# N32G432 Series Errata Sheet

NSING Technologies Pte. Ltd. Add: NSING, Teletech Park #02-28, 20 Science Park Road, Singapore 117674 Tel: +65 69268090 Email: sales@nsing.com.sg

## 13.1 CAN Active Error

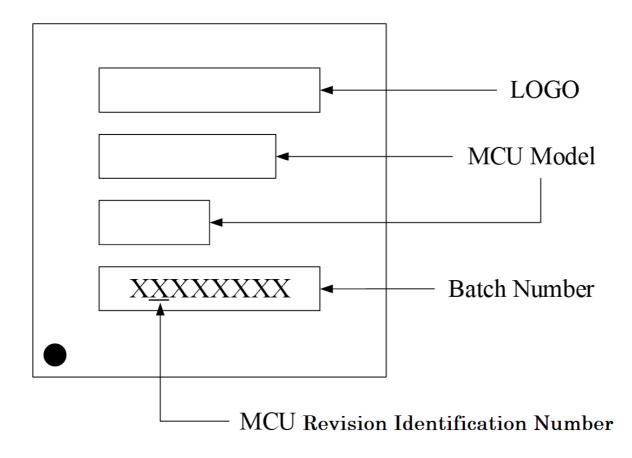
In normal mode, if the CAN bit is hard synchronized and the bus rate deviation of other nodes on the bus is too large (approaching or exceeding the synchronization segment), the CAN module is prone to report active errors.

None
